Technical Service Information

FORD 5R110W REDESIGNED SUN GEAR SHELL

Figure 1

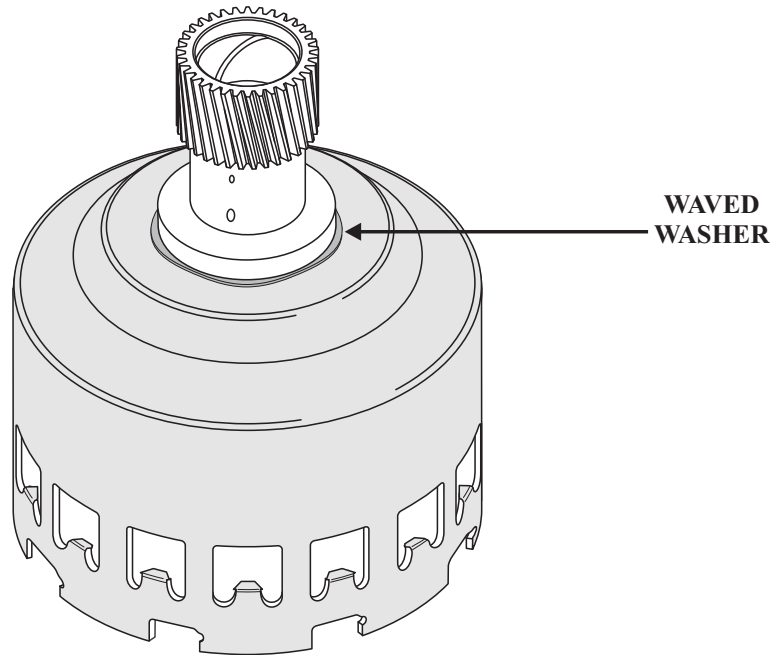
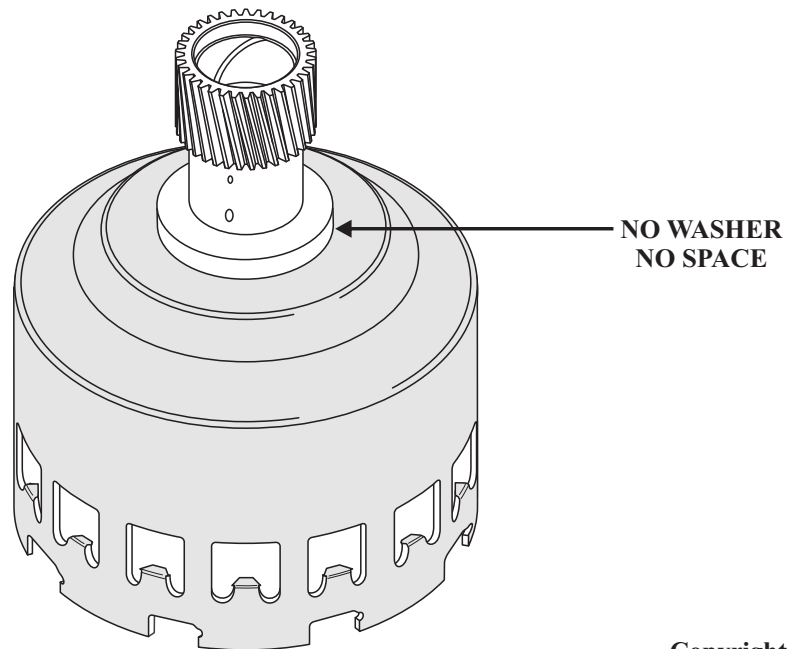
CHANGE: The Sun Gear Shell has been updated to contain a waved washer between the shell and the sun gear, Refer to Figure 1. The previous design is shown in Figure 2.

REASON: To address a noise concern.

INTERCHANGEABILITY:
The redesigned Sun Gear Shell will back service all 5R110W transmissions to the 2005 model year.

SERVICE INFORMATION:
Redesigned Sun Gear Shell.....9C3Z-7A019-A
